**Project #21-067
Legacy Landscape Shop
Located at 1221 W 2200 S**

Project Name: Legacy Landscape Shop
Proponent/Owner: Jared Hymas / MTSE Holdings
Project Address: 1221 W 2200 S
Request: Design Review Permit
Current Zoning: Commercial (COM)
Date of Hearing: December 9, 2021
Type of Action: Quasi-Judicial
Submitted By: Tanya Rice, Planner II

Staff recommends that the Planning Commission **conditionally approve** a Design Review Permit for Project #21-067 Landscape Legacy Shop, located at 1221 West 2200 South, TIN# 03-005-0019.

PROJECT NUMBER 2021-0290	
SHEET 1	OF 1
SHEET NUMBER CS101

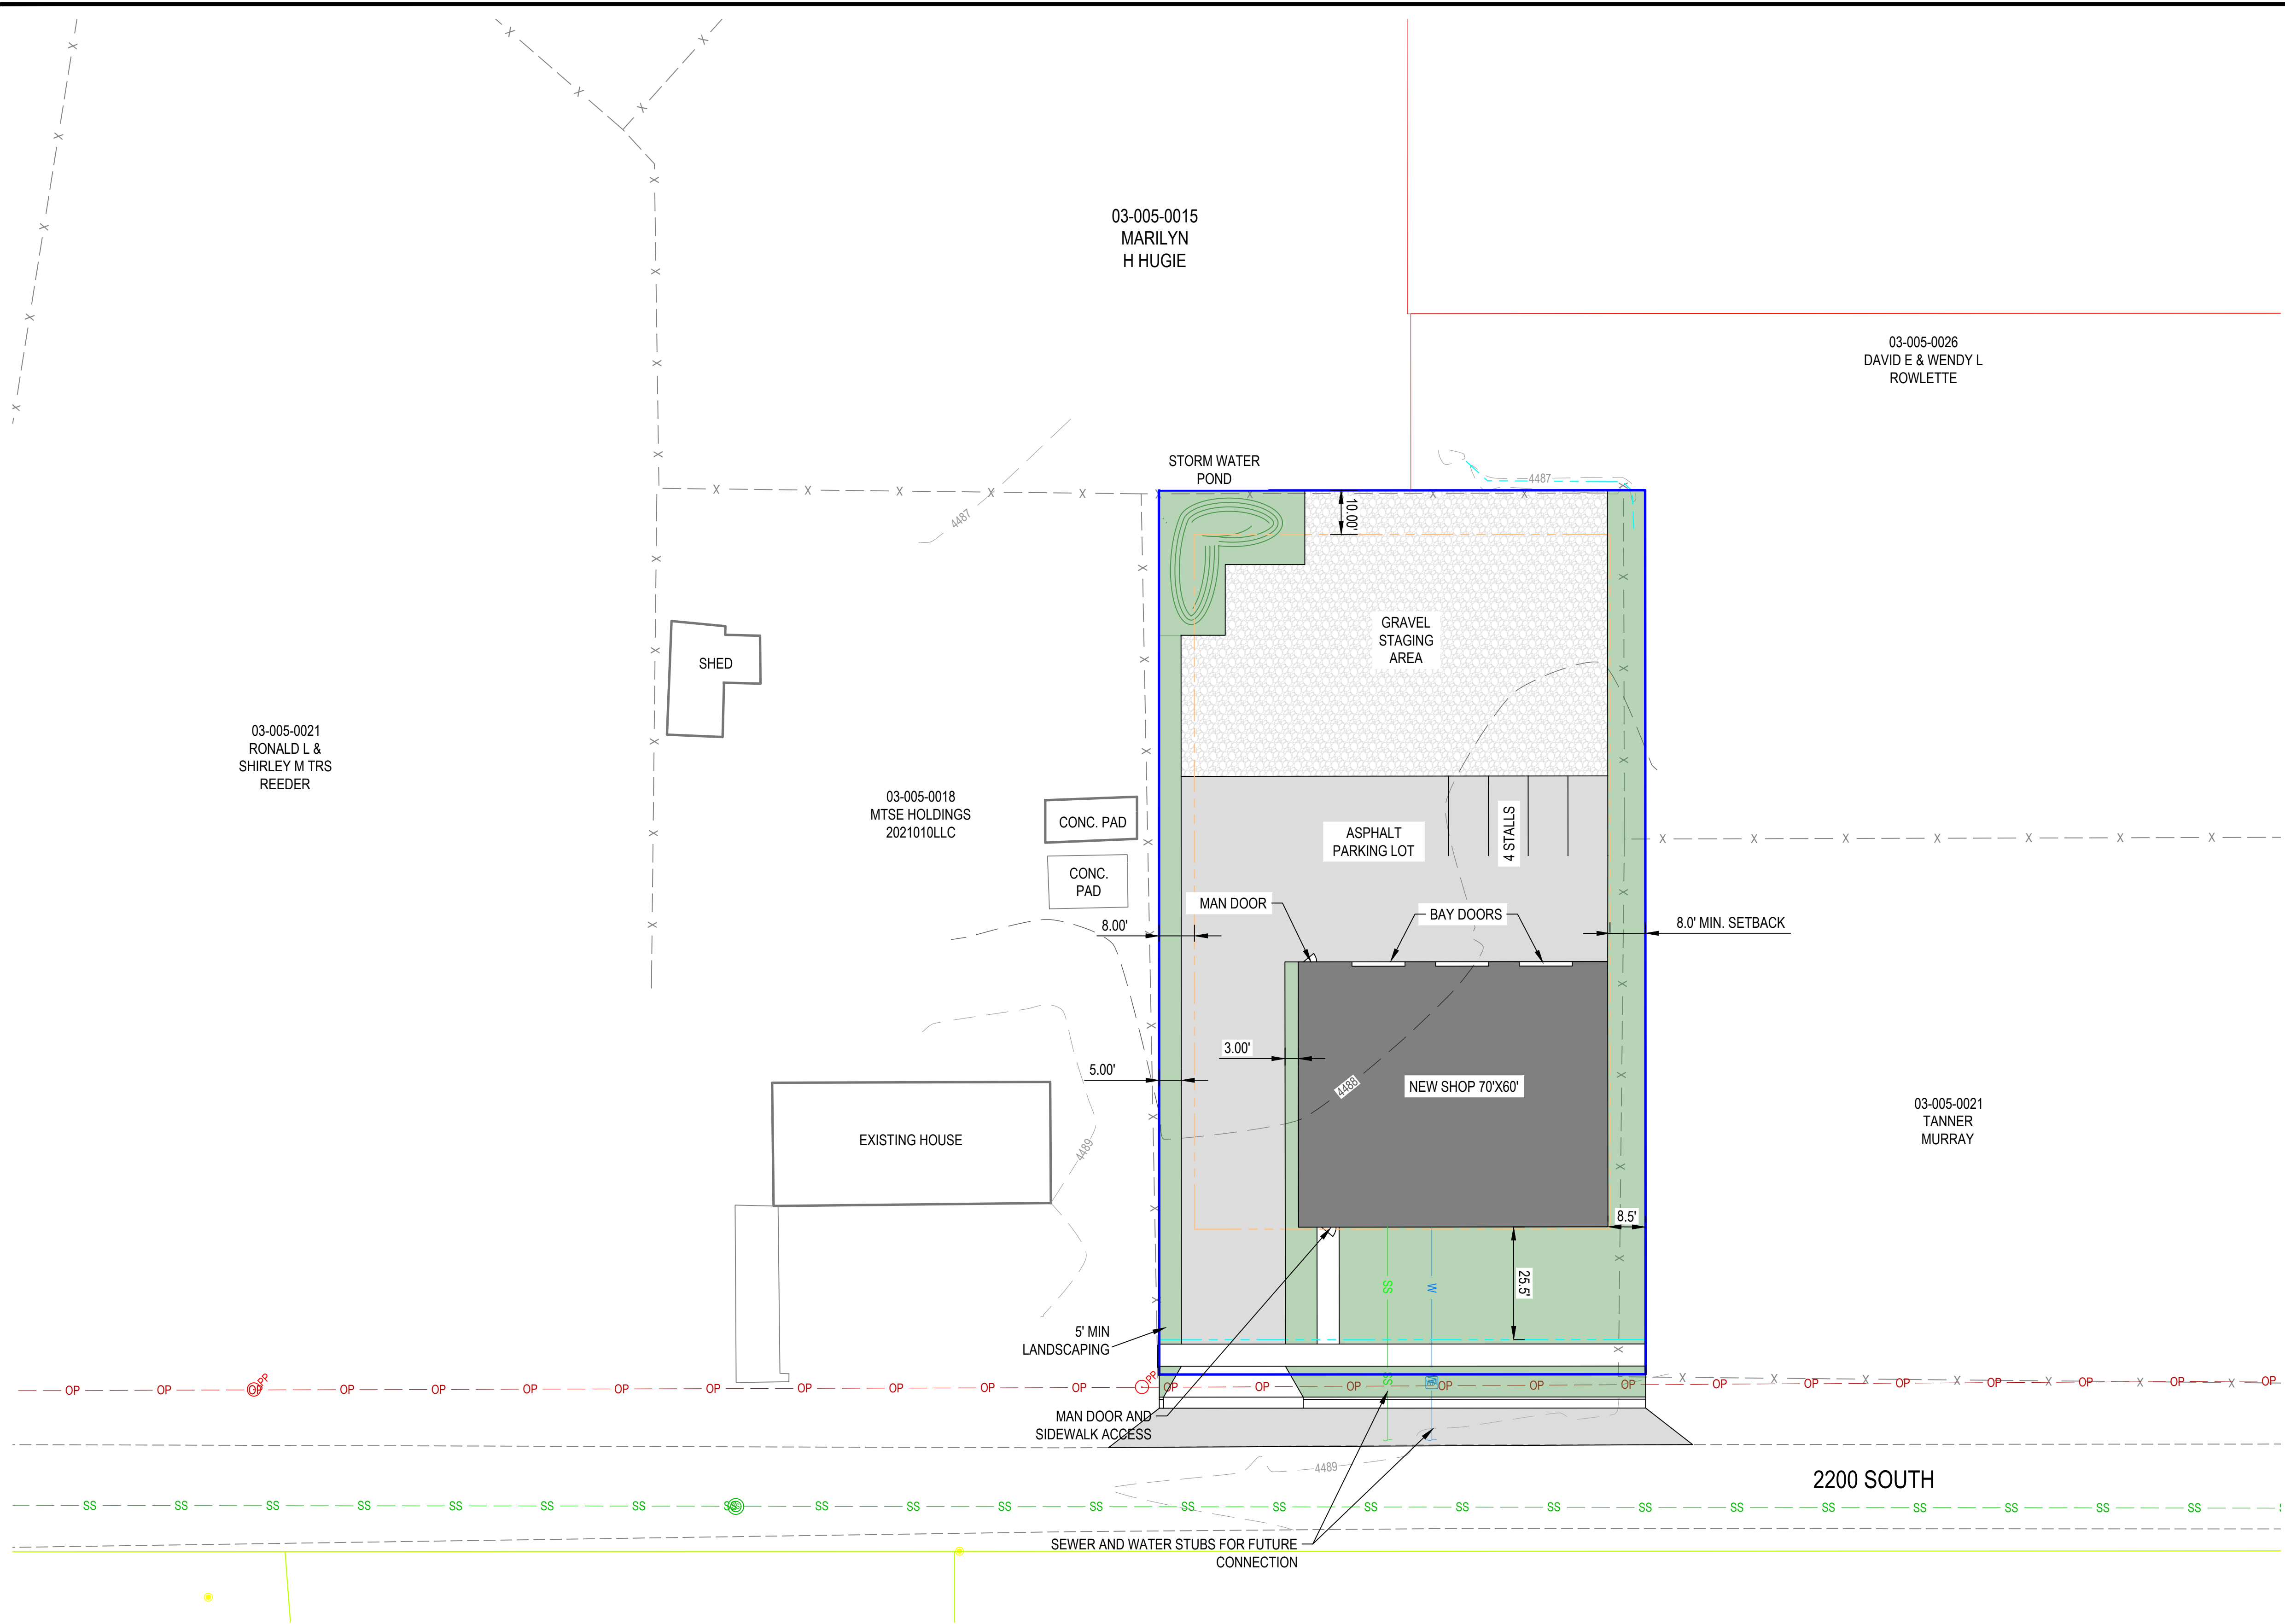
Front: (South)	25.5"
Side: (West)	28'
Side: (East)	8'
Rear: (West)	>100'
Parking (Rear)	60'
Parking (Side)	8'

Because the proposed use involves a contractor type of business, no outdoor storage is permitted in the COM zone, and no parking is allowed in undeveloped open areas (labeled as “gravel staging area” on plans). As conditioned, outdoor storage is not permitted in this area.

3. No parking shall be permitted in the undeveloped gravel staging area.
4. A performance landscaping plan, prepared in accordance with §17.32 of the LDC, shall be submitted for approval to the Community Development Department prior to the issuance of the building permit. The plan shall include the following:

EXTERIOR ELEVATIONS

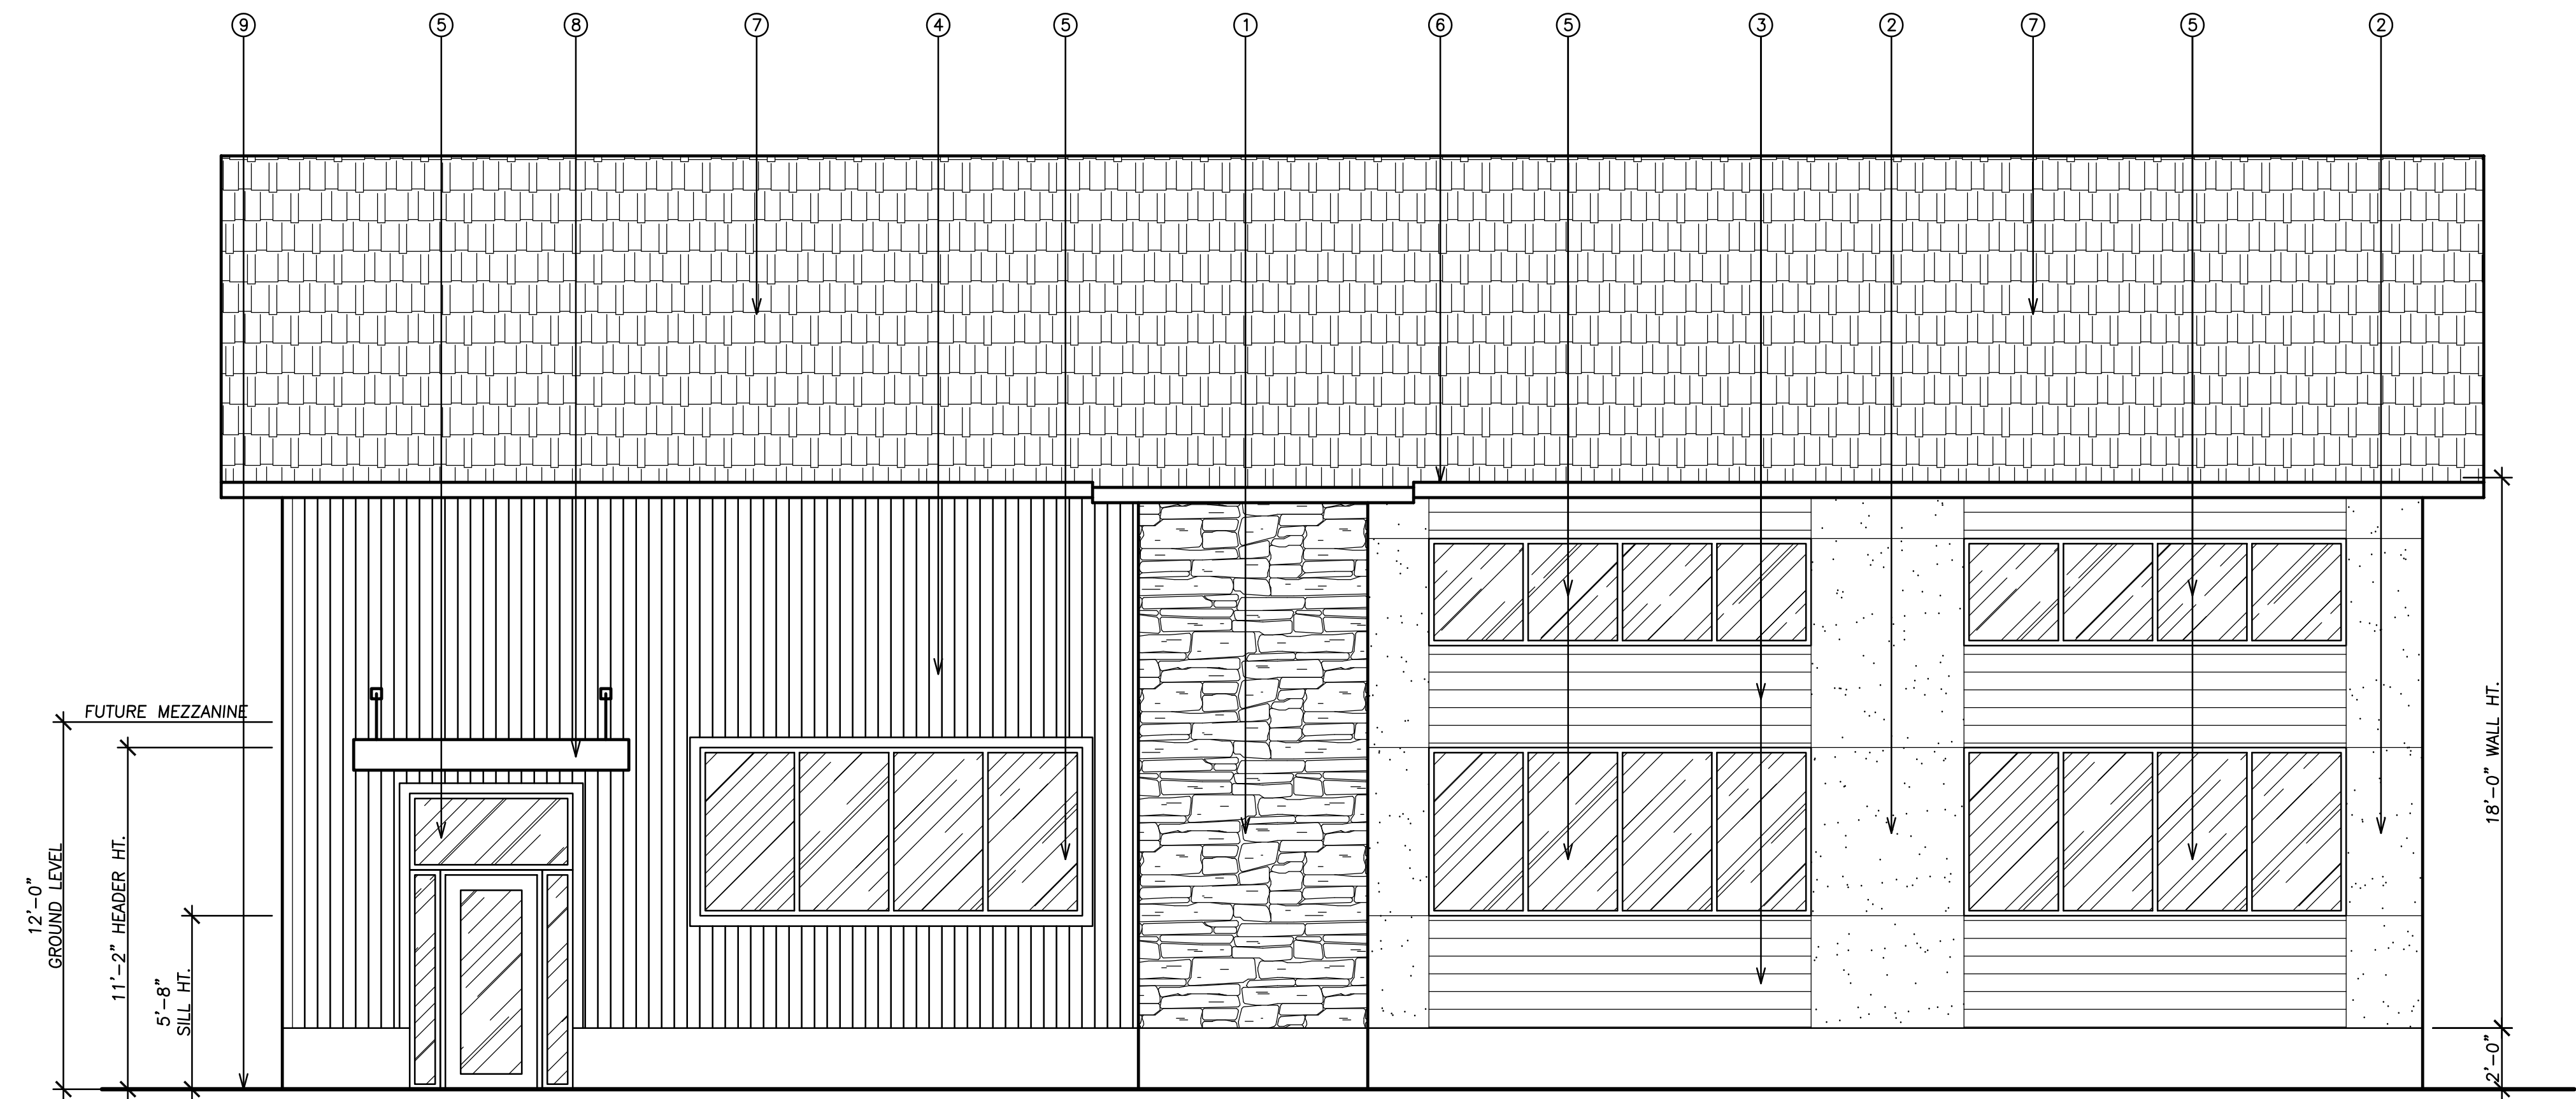
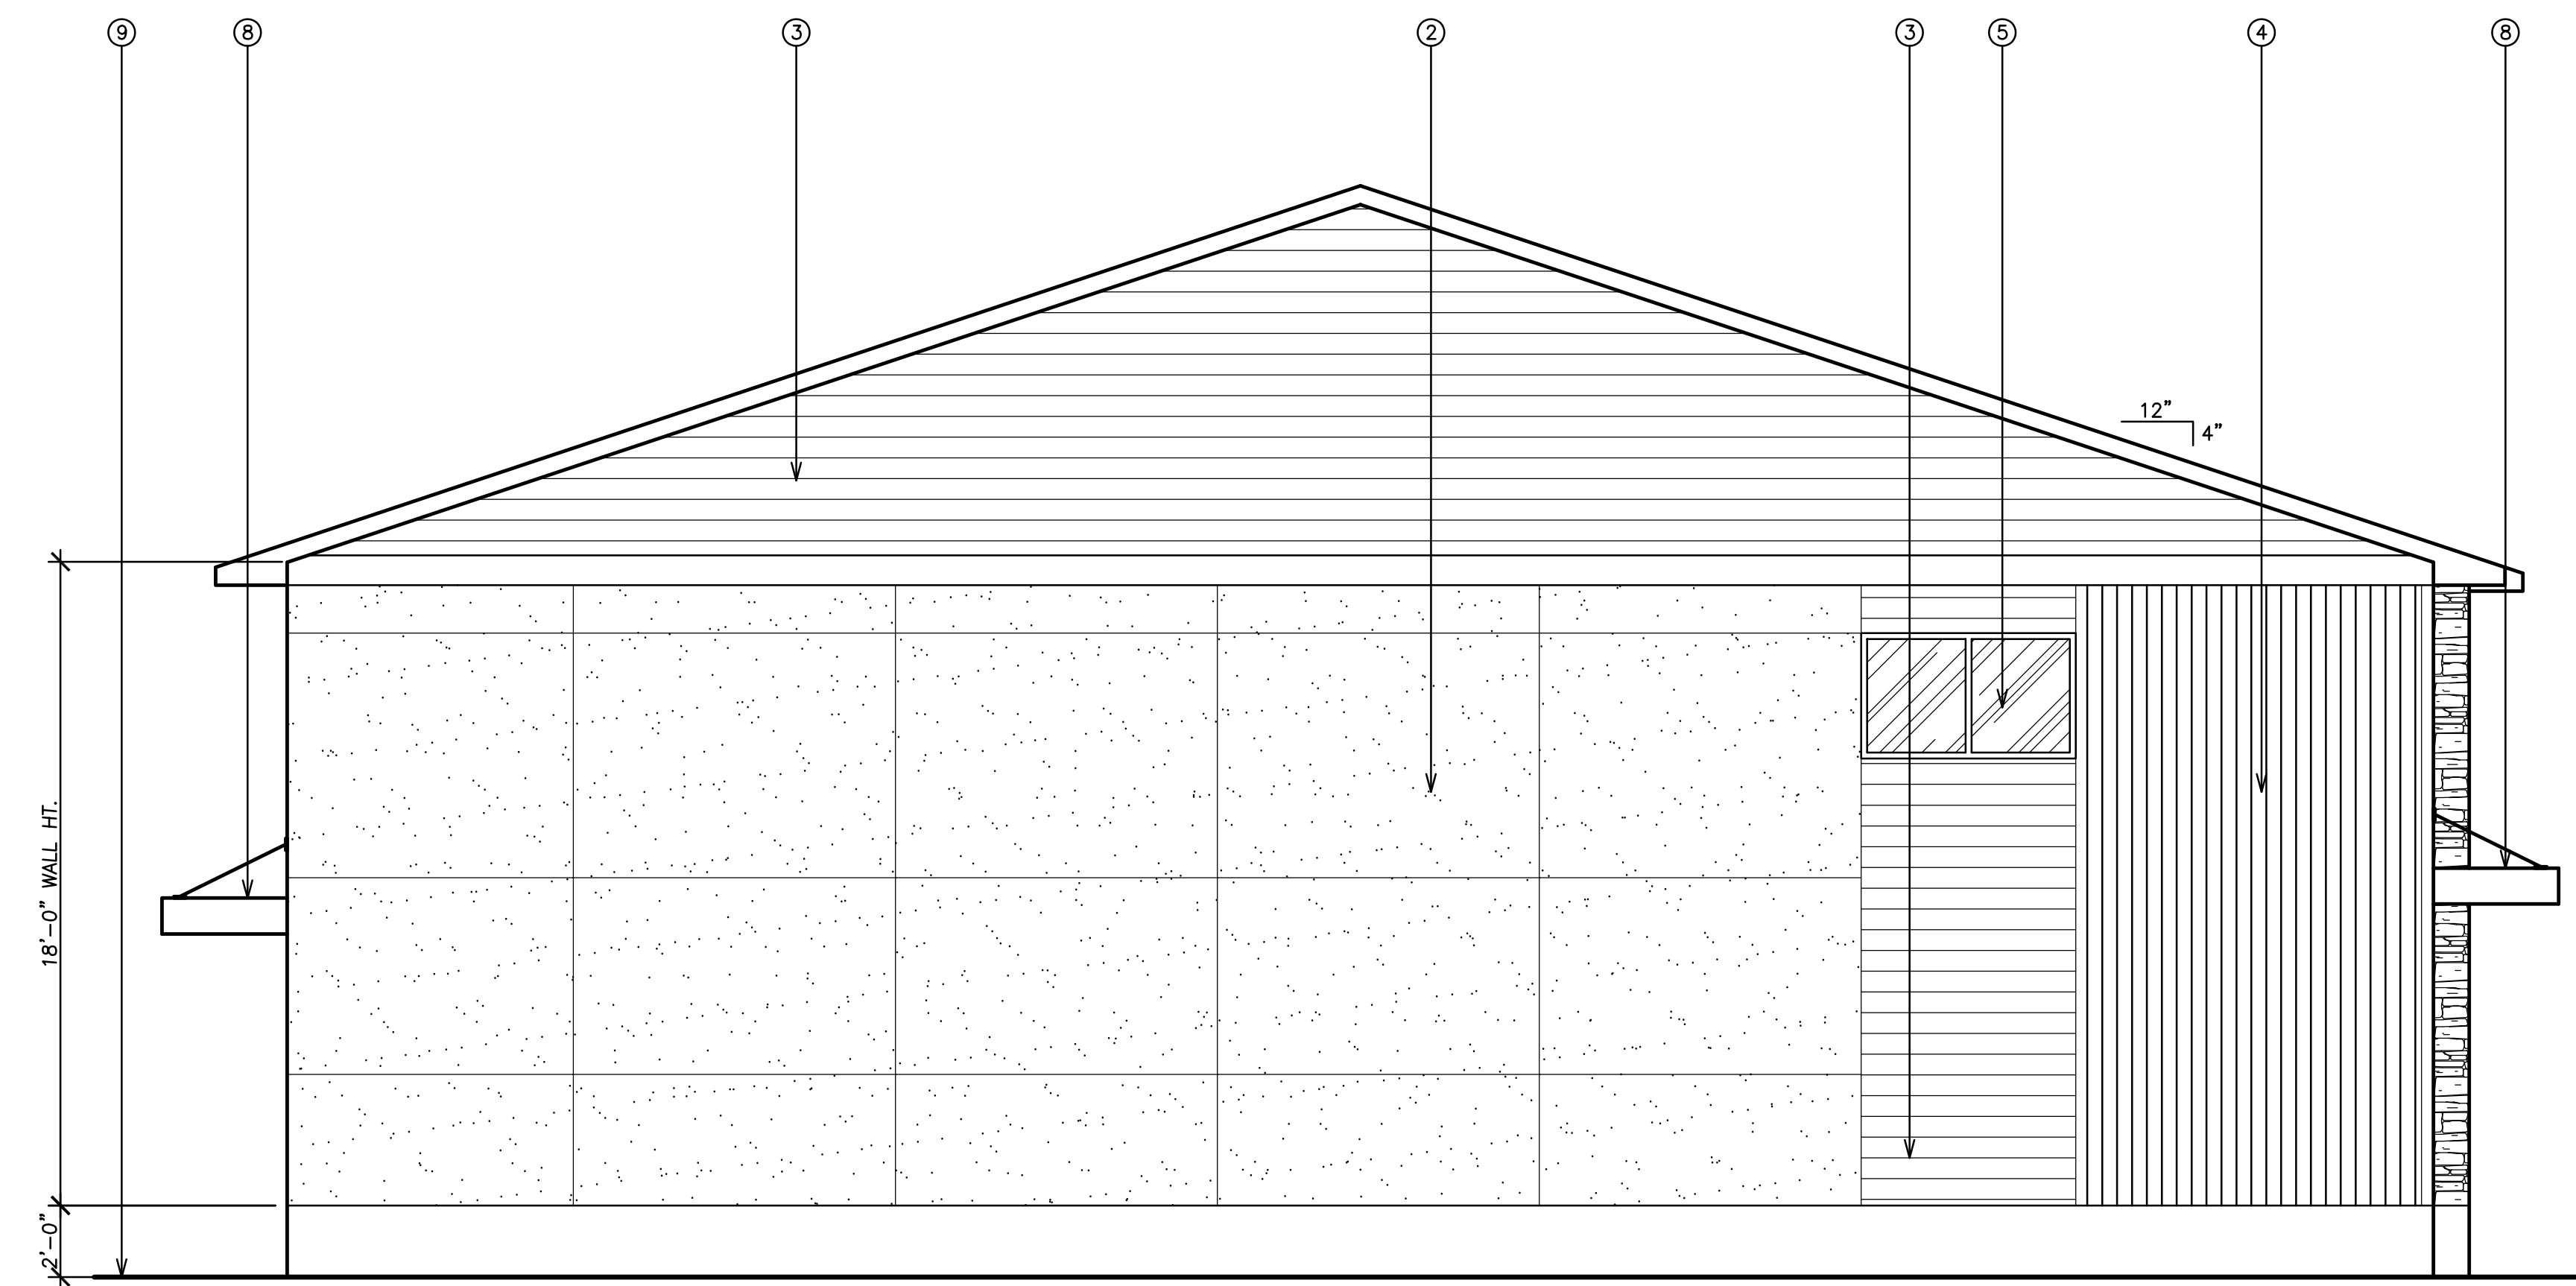
The building design and material distribution around the building lacks 4-sided architectural design. A maximum of 40 linear feet of blank, flat wall is permitted without architectural variation, but the proposal shows approximately 50’ of blank walls on each side elevation. As conditioned, the design standard for this proposal meets the requirements of the LDC.

- c) A total number 10 trees per acre and 25 shrubs/perennials per acre of the final project site shall be provided.
5. The east and west side façades shall have architectural breaks every 40'.
